PROPOSAL FOR AMENDMENTS TO REGULATION No. 58

- I. Rear Underrun Protection Devices (RUPDs)
- II. Vehicles with regard to the Installation of an RUPD of an approved type
- III. Vehicles with regard to their Rear Underrun Protection (RUP)

Note: The text reproduced below was prepared by the expert from Germany to introduce more stringent requirements for rear under run protection devices. This document supersedes document GRSG/2011/19. The modifications to the current text of the Regulation are marked in **bold** for new characters or marked strikethrough for deleted characters.

Figure 1

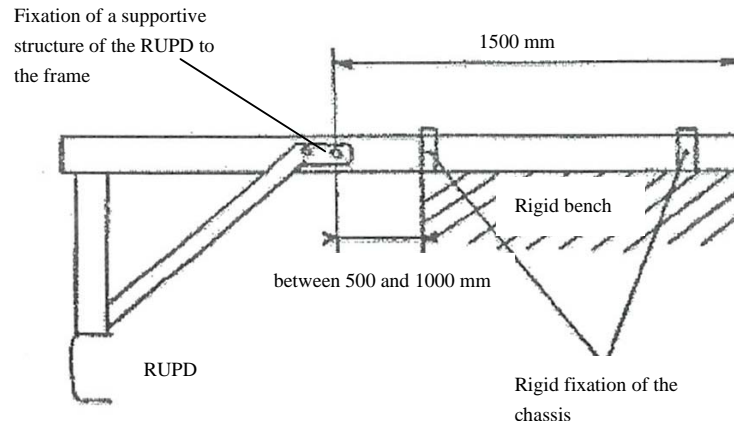
Paragraph 1.1.3., amend to read:

"1.1.3. On a rigid test bench (see figure 1).
